RSL LifeCare Montgomery Centre ANZAC Village DA SUBMISSION

REVISION NOTES:
Revision Cloud 1 = Deletion of previously proposed mechanical exhausts stacks (x2), condenser platform, and access ladder.
Revision Cloud 2 = Previously proposed platform for mechanical condensers shifted from west to east. Louvred screen to conceal condensers added to south and west facing side of platform.
Revision Cloud 3 = Stairs increased width and the ramp moved next to the existing building.
Revision Cloud 4 = Parking near the Memorial Stage and planter walls design amendments.
Revision Cloud 5 = View of southern side of hall shows of deletion of previously proposed mechanical exhausts stacks (x2), platform, and access ladder. Louvred screen to conceal condensers platform can be seen.
Revision Cloud 6 = Finishes materials added
Revision Cloud 7 = Previously Anzac memorial was demolished. New proposal to retain the existing Anzac memorial and extend as represented in the proposed plans.

project Anzac Village-Montgomery Centre		date 7/5/2025	revision issue 06
project number 23010	client RSLLC	drawing scale @ A1	drawing number A000
drawing COVER PAGE

PROPOSED GROUND FLOOR PLAN
1:100

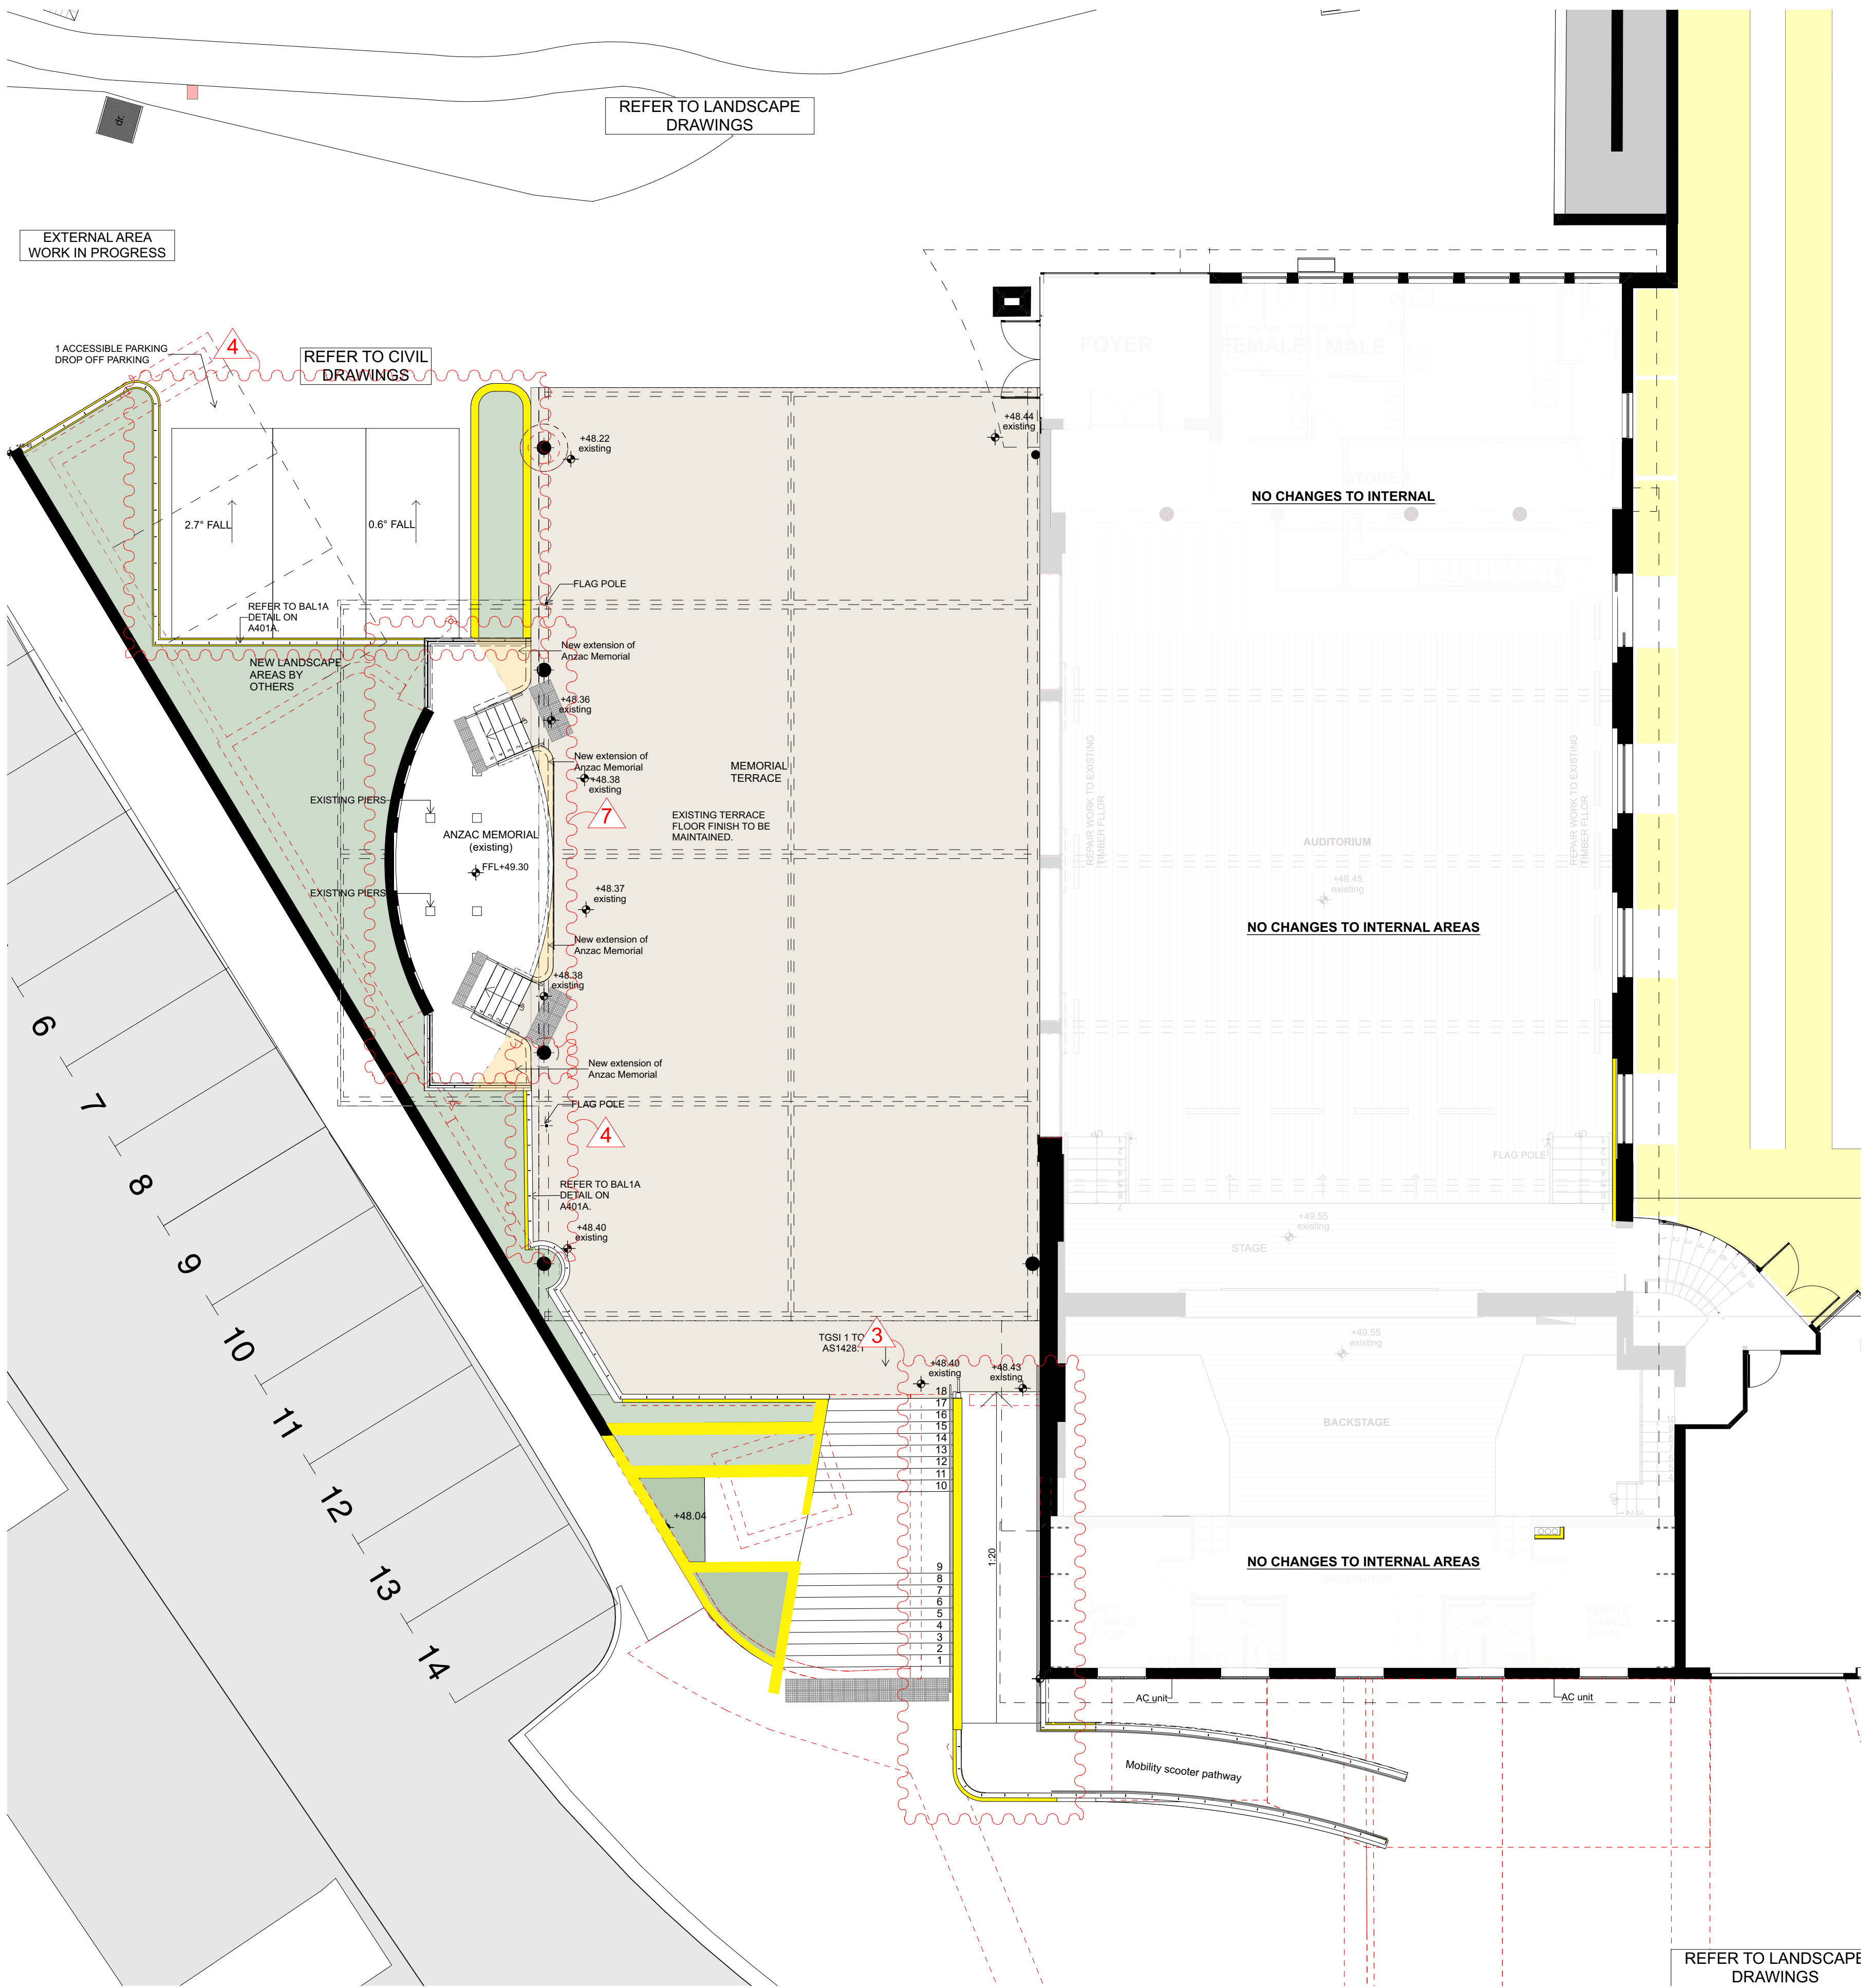
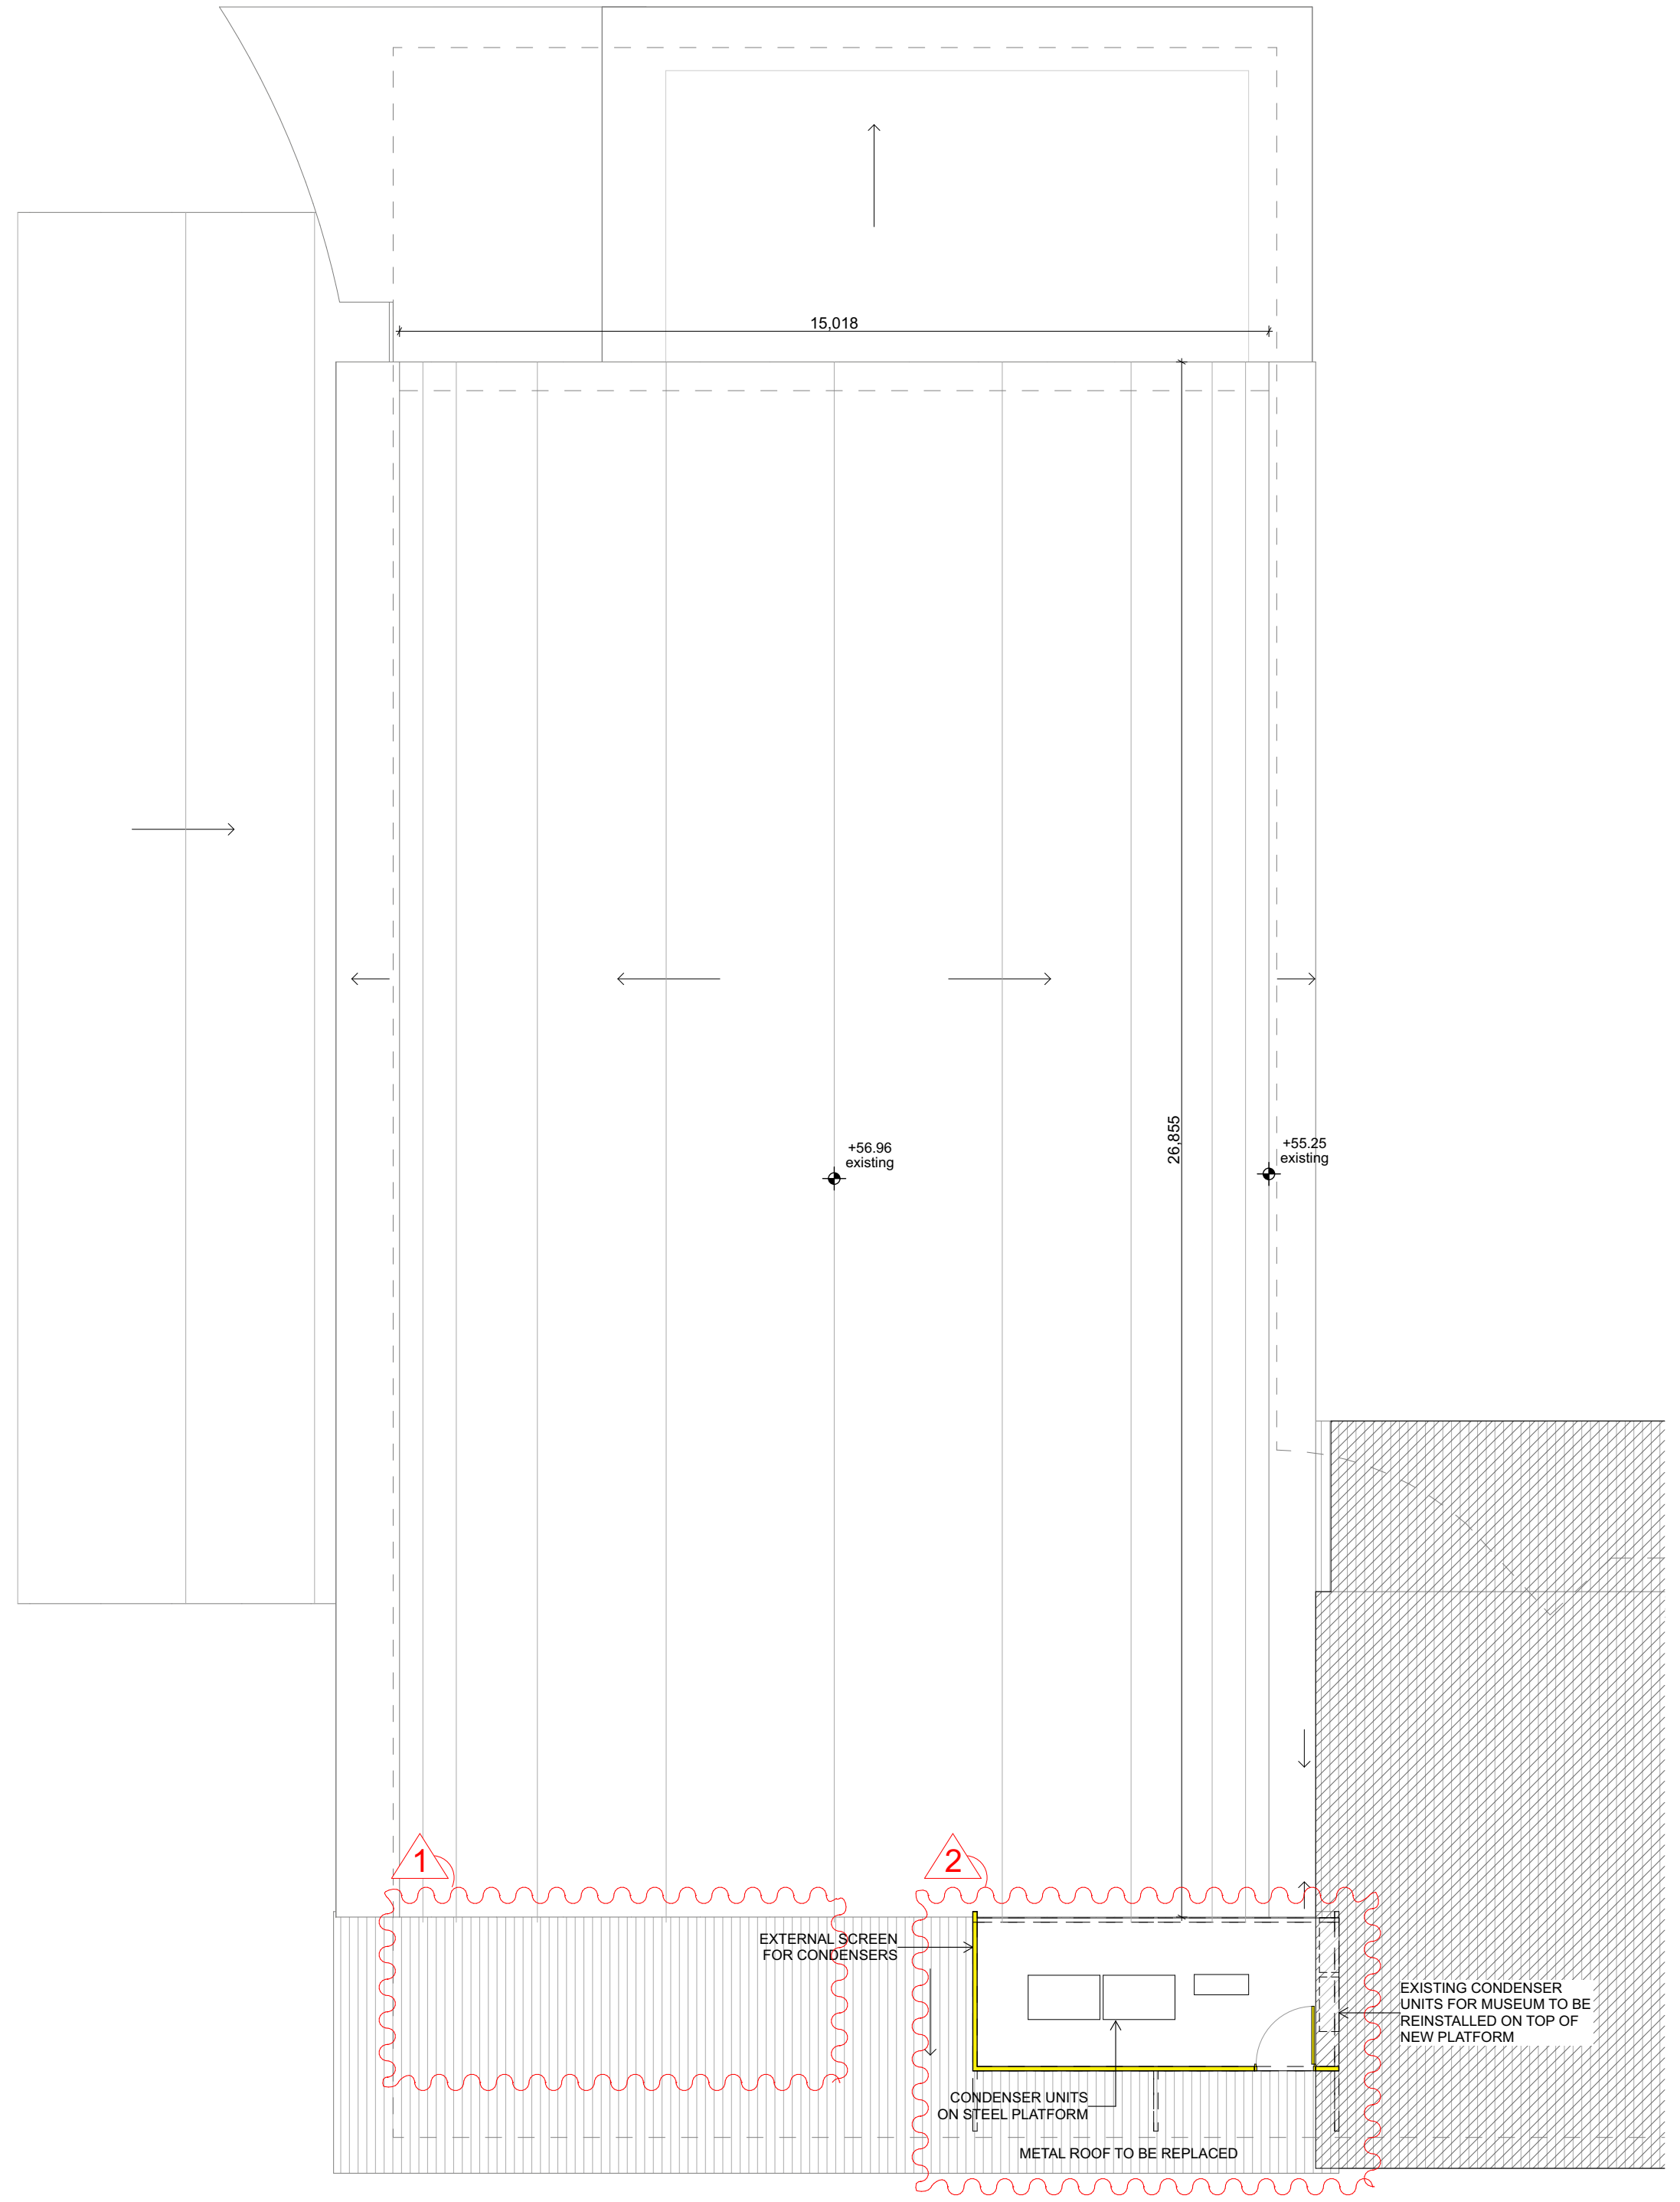
REVISION NOTES:
Revision Cloud 1 = Deletion of previously proposed mechanical exhausts stacks (x2), condenser platform, and access ladder.
Revision Cloud 2 = Previously proposed platform for mechanical condensers shifted from west to east. Louvred screen to conceal condensers added to south and west facing side of platform.
Revision Cloud 3 = Stairs increased width and the ramp moved next to the existing building.
Revision Cloud 4 = Parking near the Memorial Stage and planter walls design amendments.
Revision Cloud 5 = View of southern side of hall shows of deletion of previously proposed mechanical exhausts stacks (x2), platform, and access ladder. Louvred screen to conceal condensers platform can be seen.
Revision Cloud 6 = Finishes materials added
Revision Cloud 7 = Previously Anzac memorial was demolished. New proposal to retain the existing Anzac memorial and extend as represented in the proposed plans.
